Illinois Department of Transportation

FAS Route 1279 Section (1)BR & I LaSalle County P-93-035-01 SN 050-0088

IL Route 178 over the Illinois River at Utica

We have reviewed the Consultant prepared Bridge Condition Report (BCR). The BCR recommends:

Route FAS 1279 Sheet of Section (1) BR & I Computed by AR Date 12/2/03 County LASALLE Checked by Date

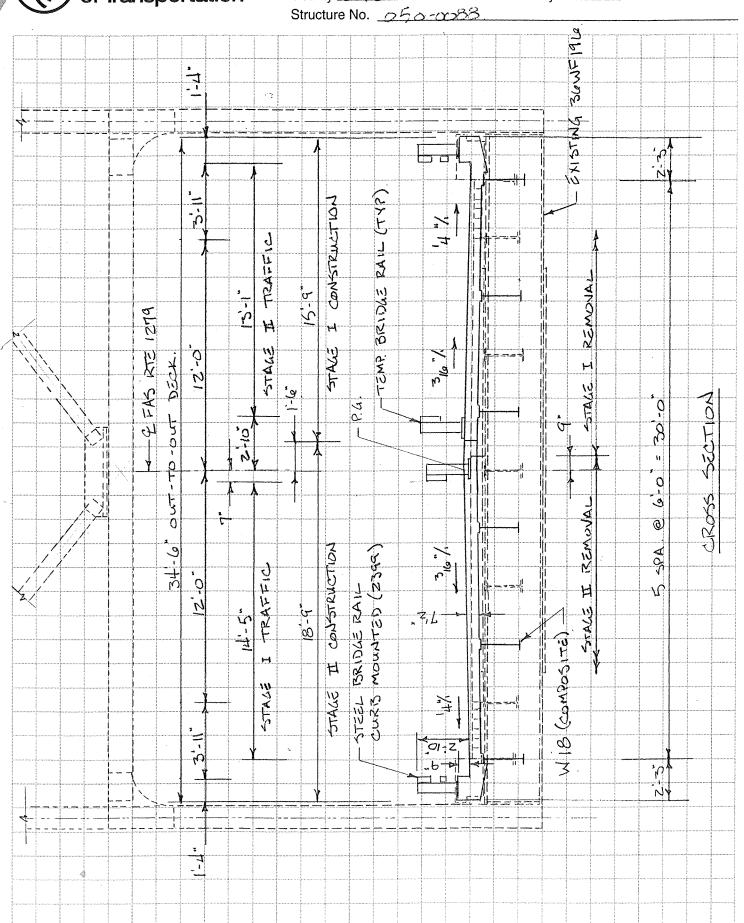
- 5. Installation of new navigation and/or roadway lighting systems is at the District's discretion in coordination with the US Coast Guard.
- 6. We suggest that a deck width of 34'-6" out-to-out be considered. See attached sketch for a proposed cross section. To reduce dead loads and maximize bridge clear width, we recommend the use of Steel Bridge Rail Curb Mounted (2399). Preliminary calculations indicate that a future wearing surface will not be allowed.
